PLANNING COMMISSION MEETING

**WHITE LAKE TOWNSHIP
PLANNING COMMISSION
FEBRUARY 5, 2026**

We have conducted a review of the final site plan dated February 6th, 2026 for the Lasting Impressions development. Our review of the preliminary site plan was conducted while the project was already engaged in the Township’s revise and resubmit process prior to our services being contracted for site plan review. For that reason, a full preliminary site plan report was not generated.

Site / Construction Plan Review

SHEET NUMBER: **C1.02**

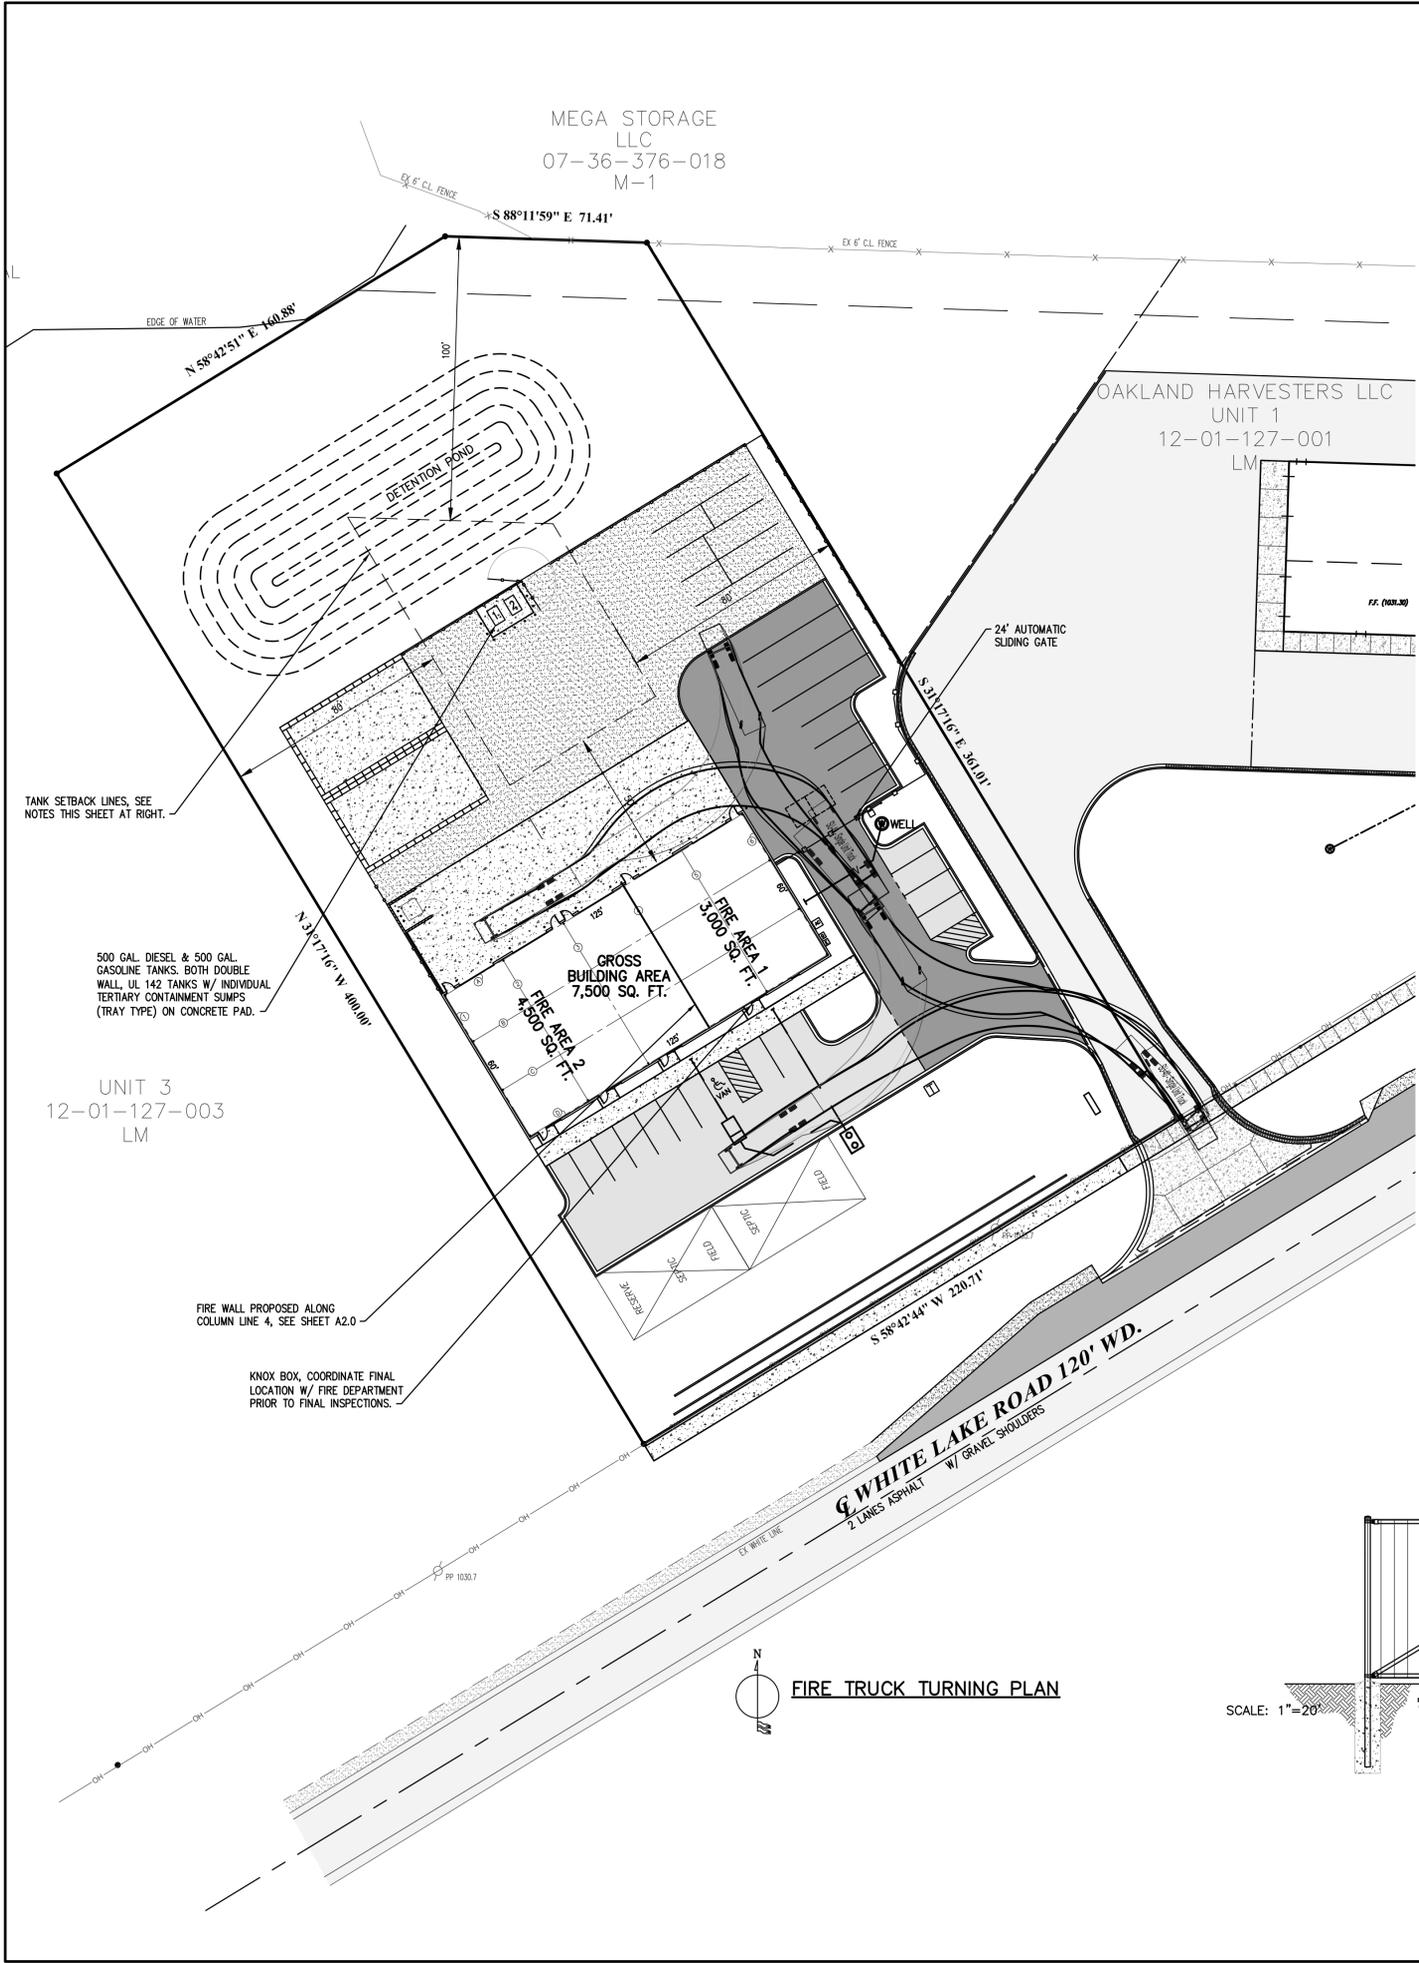
1. *Cover Sheet G0.01-Sheet C1.31 Utility Plan is missing from the Sheet Index. **Comment addressed. Utility plans added.***
2. *Sheet C1.02- Building Information- Update Gross area to 7,500 SF. **Comment addressed. Area updated.***

5. Provide detailed plans for fuel storage tanks
 - Vehicle Impact guards (4" Steel Posts, 3' embed, -3' above grade, spaced $\leq 4'$)
 - Installed per manufacturer

PROJECT NUMBER: 24004
 SHEET NUMBER: **C1.21**

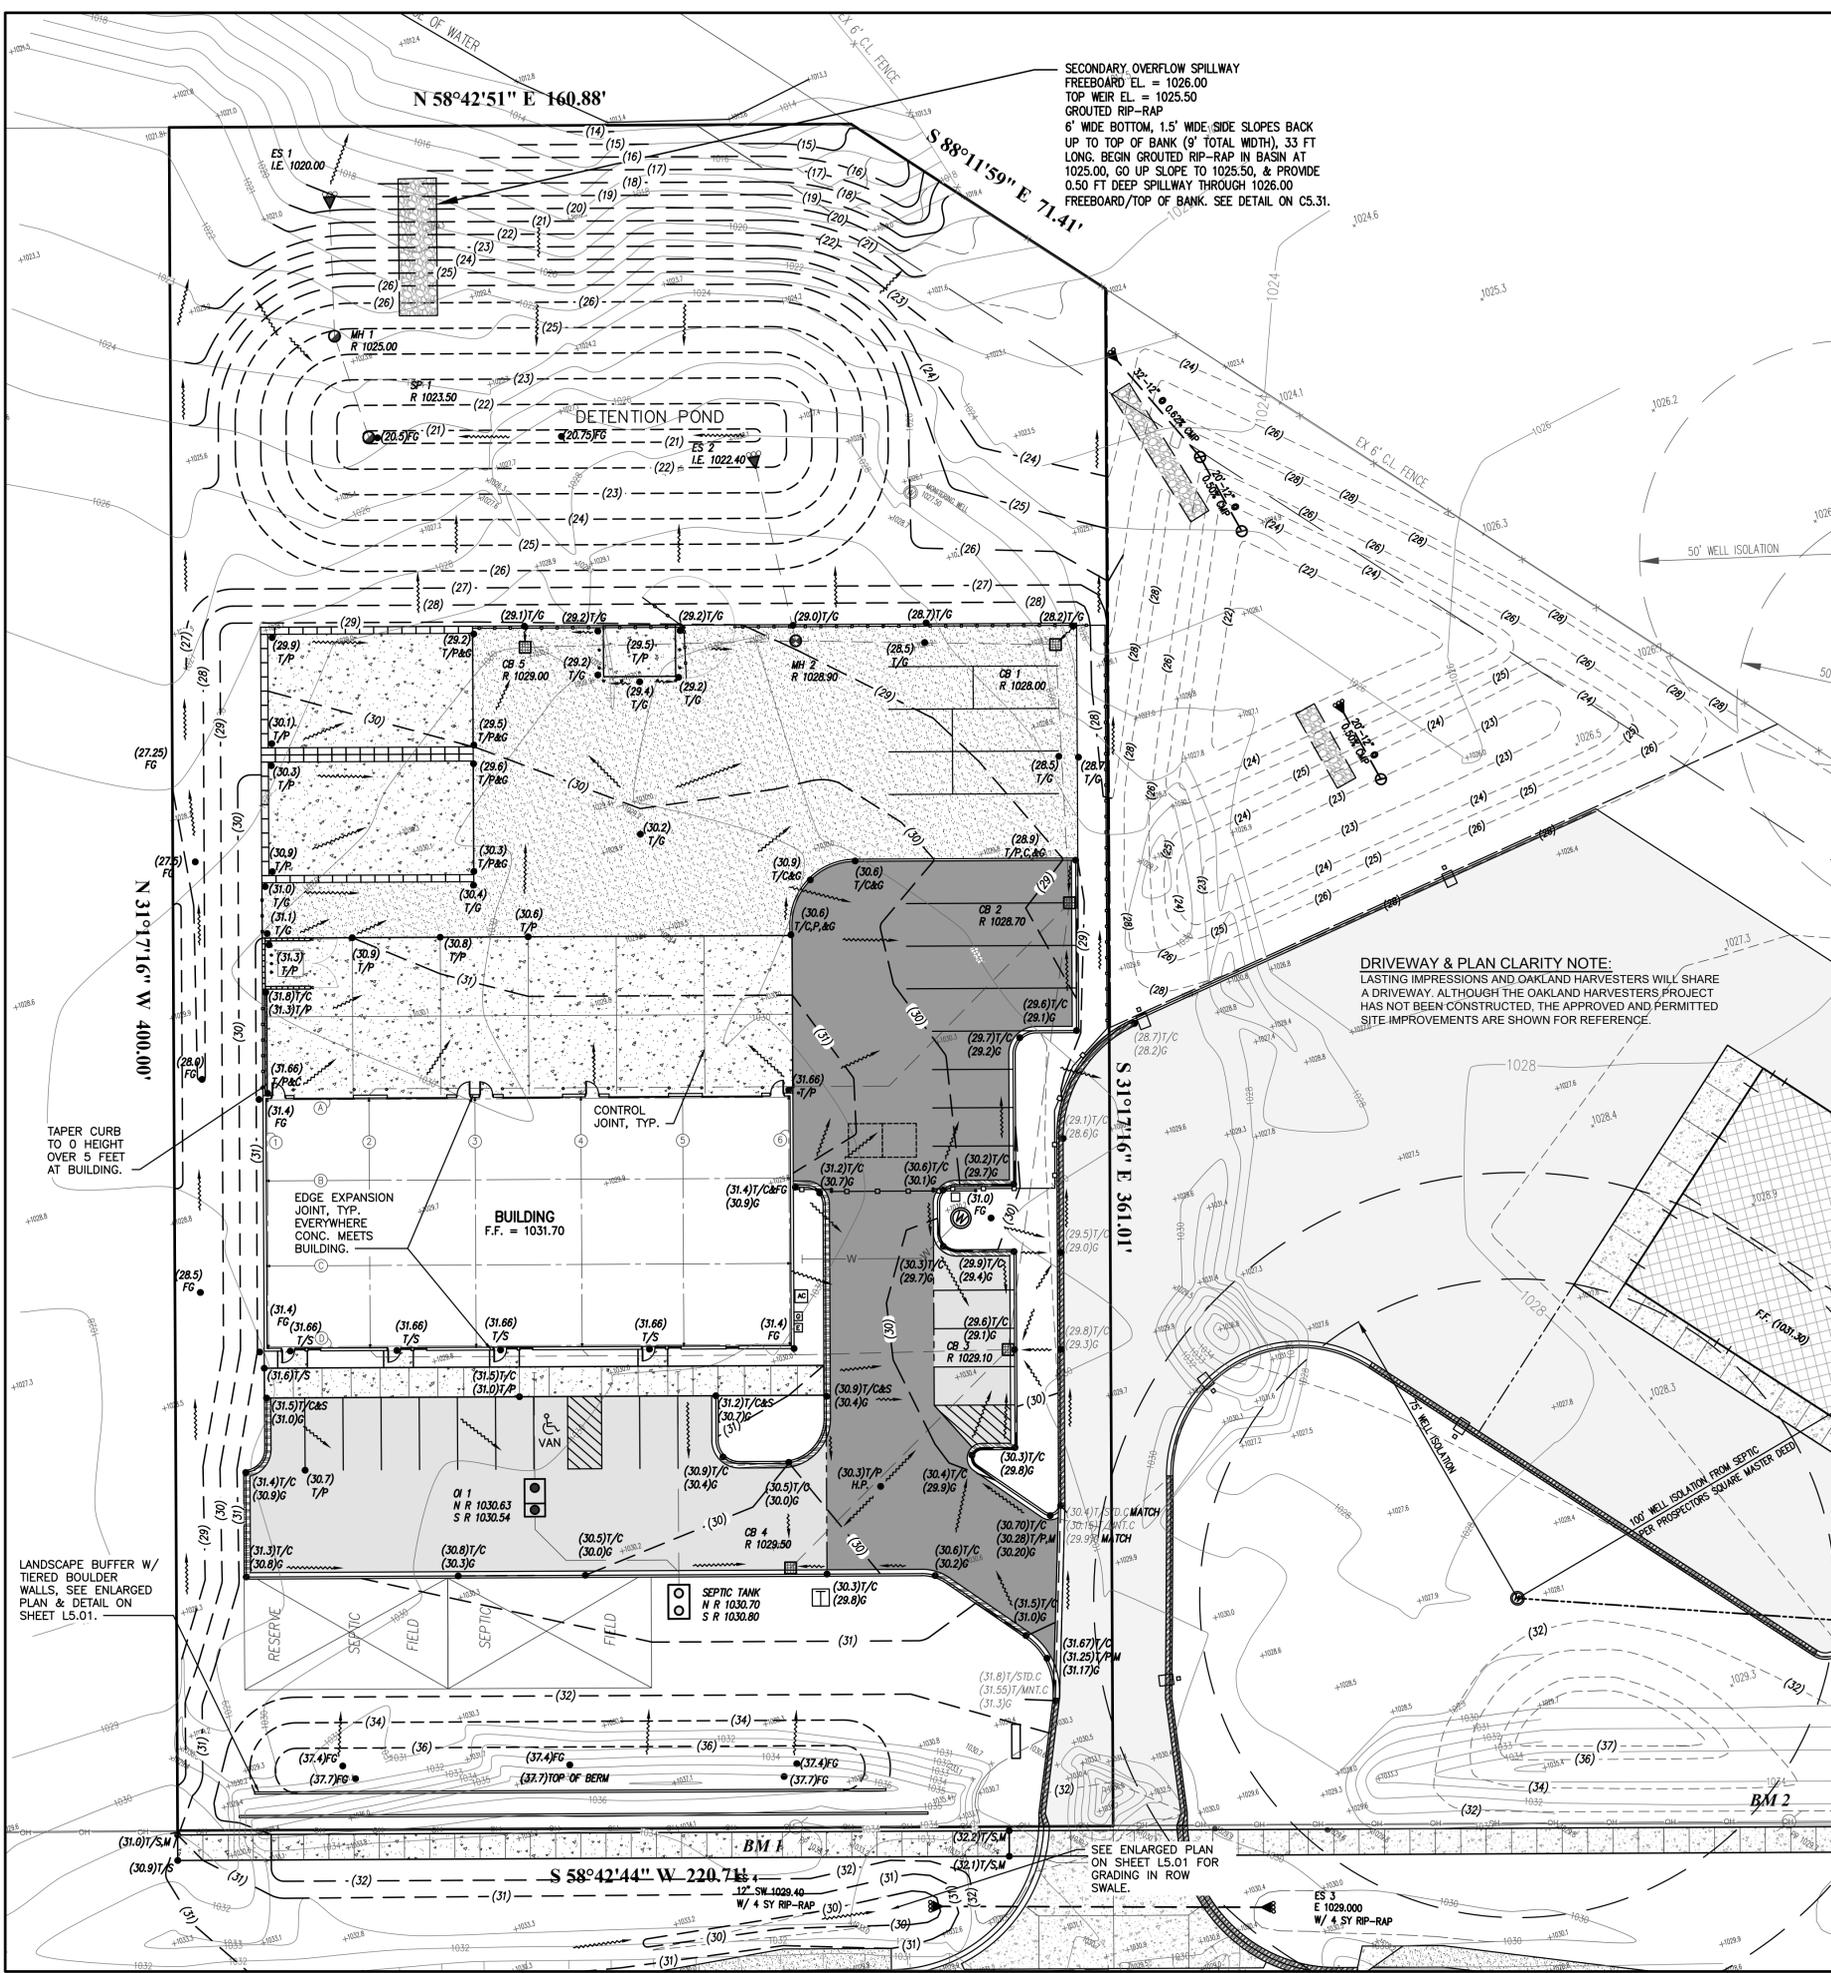
7. Sheet C1.21-South side of building-northwest corner of island- Proposed grades (30.9 T/C&S, 30.4G) do not match grades in the same area on the Enlarged Accessible Parking Grading Plan (31.2 T/C&S, 30.7G). **Comment addressed. Grades were corrected.**

9. Sheet C1.21- Note regarding Secondary Overflow Spillway- Line 7-'Begin in basin at 1025.00' should be 1025.50 (otherwise primary overflow would not be needed); Line 8- 1026.00 should be approximately 1019.00. Please revise all relevant sheets. **Comment addressed. Comment regarding line 8 to be withdrawn.**

SHEET NUMBER: C1.31

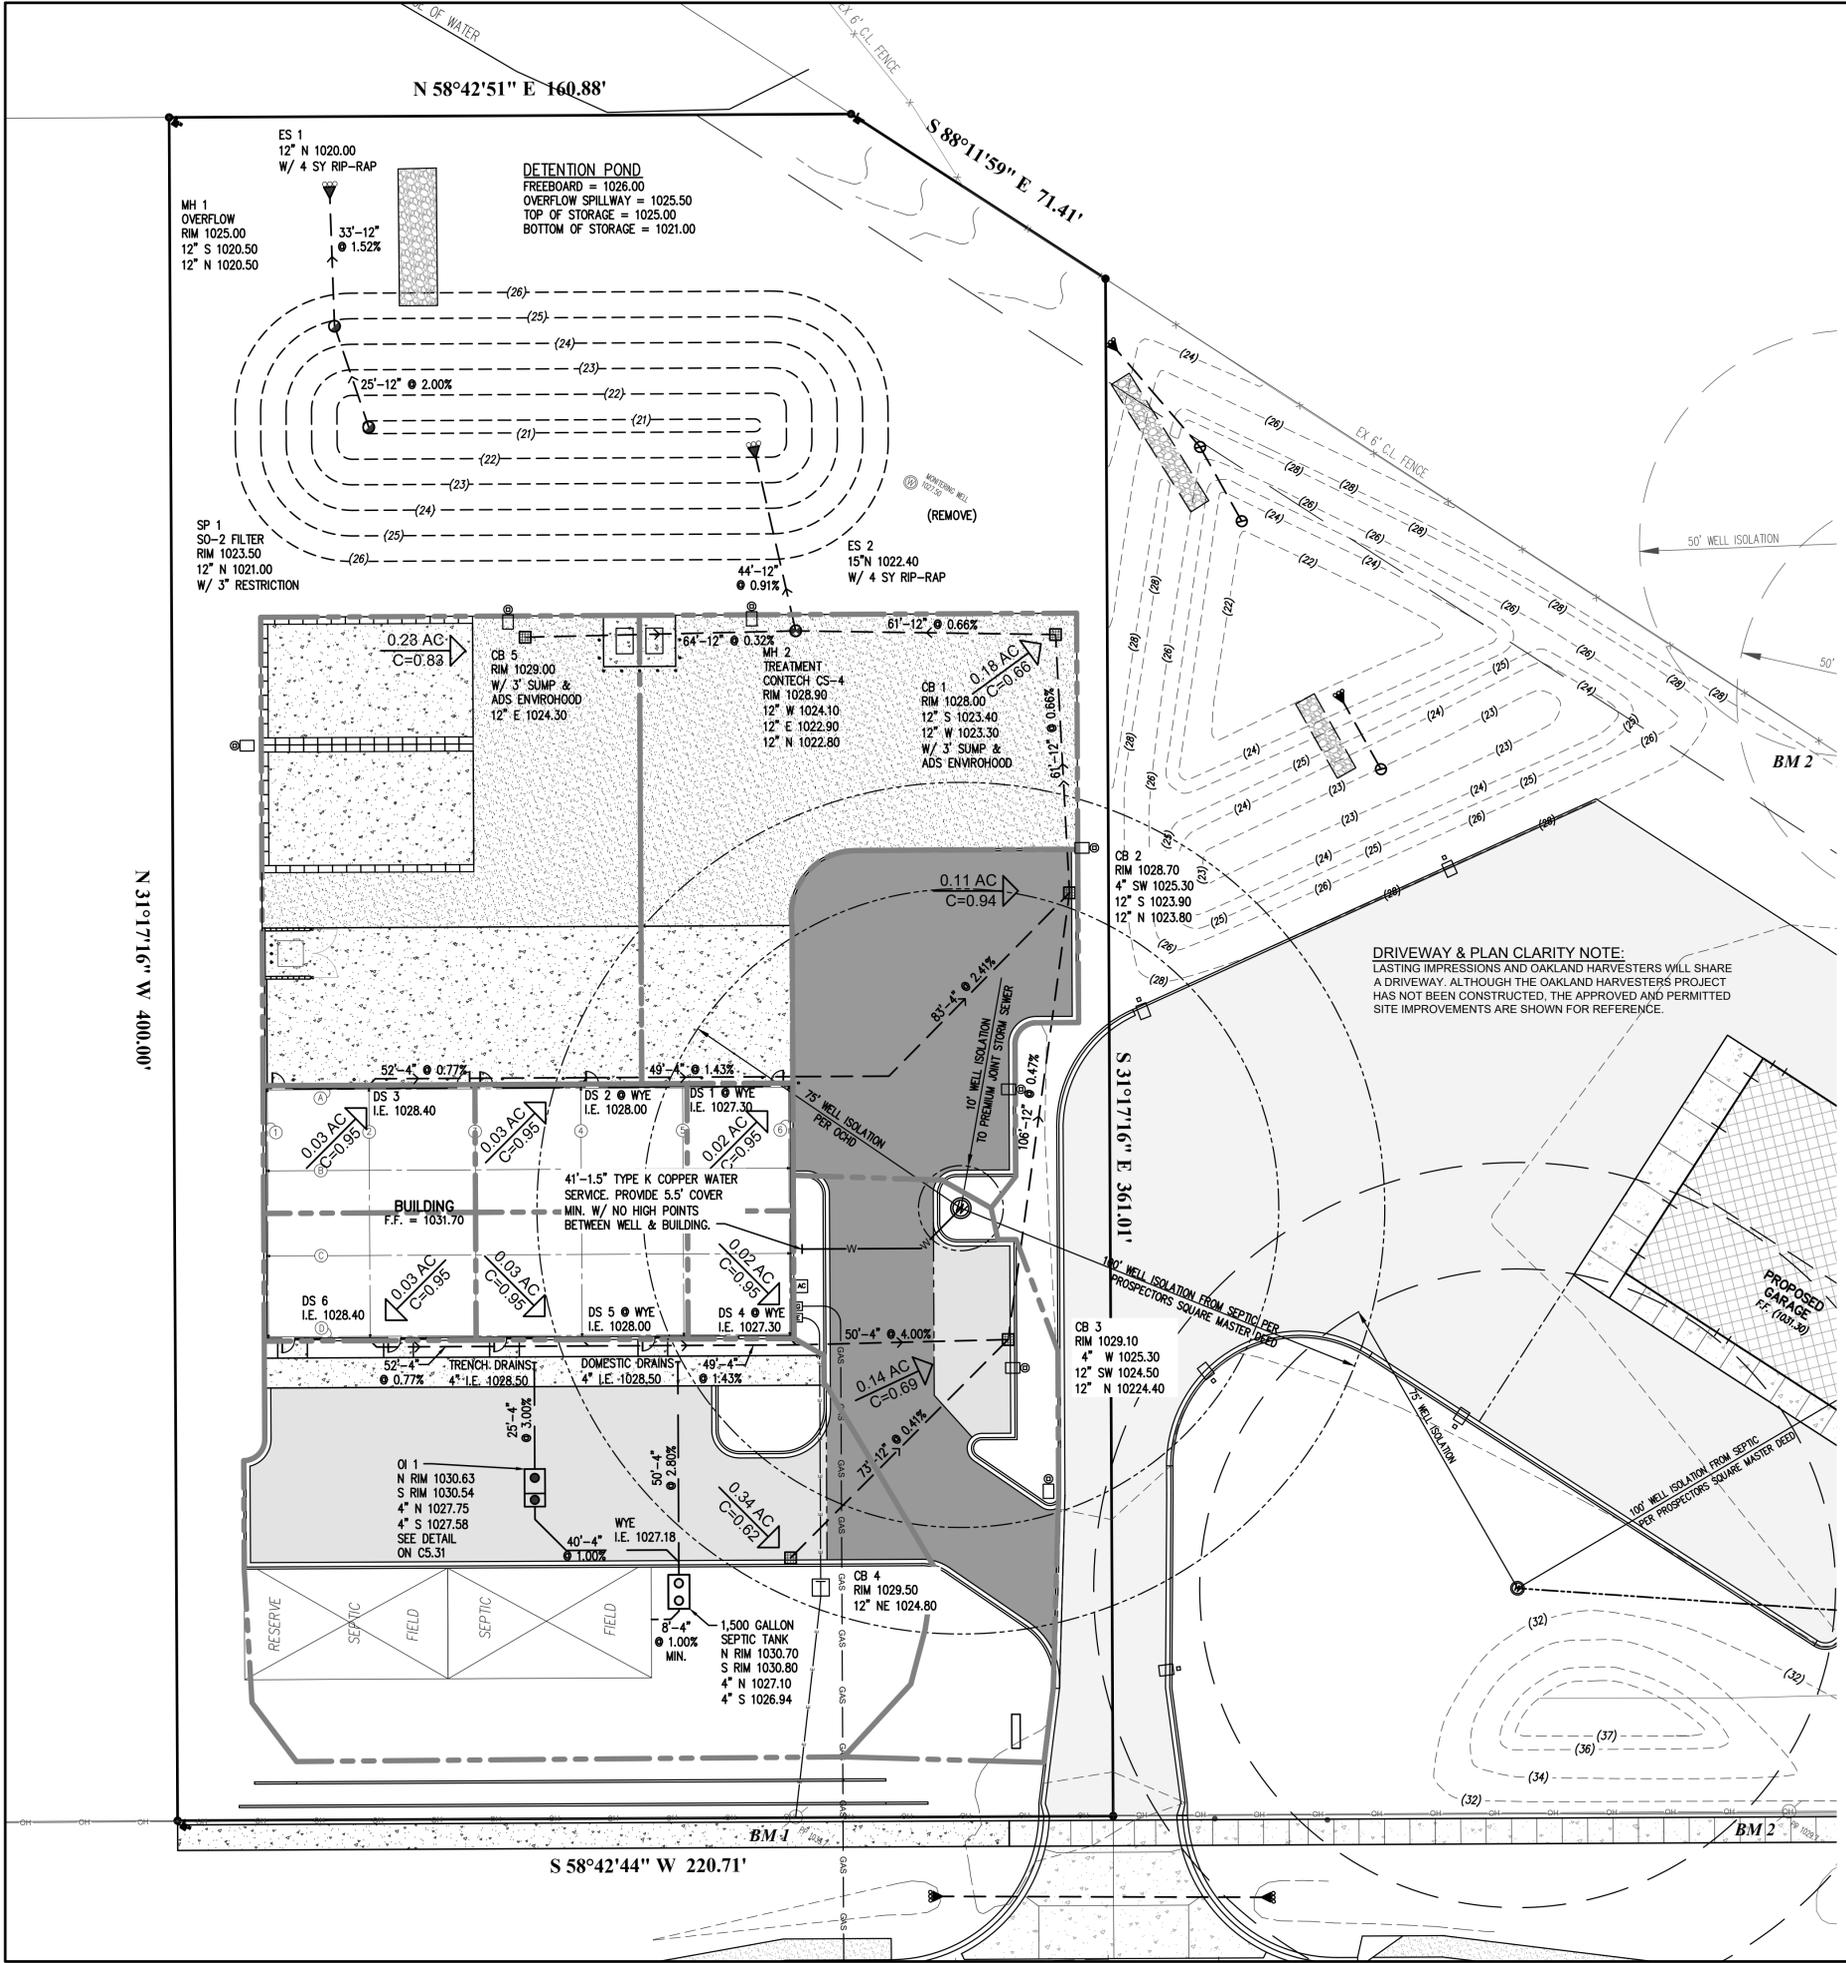
3. Sheet C1.31- 25' lead at 1.00% (from trench drains IE 1028.50 to OI 1 IE 1027.75) we calculate pipe slope to be 3.00%. Please verify. **Comment addressed. Slope updated to 3.00%.**
4. Sheet C1.31- Provide/specify cleanouts at changes in direction of sanitary lead. **Comment addressed, Applicant provided description of proposed grease interceptor which provides cleanout access.**
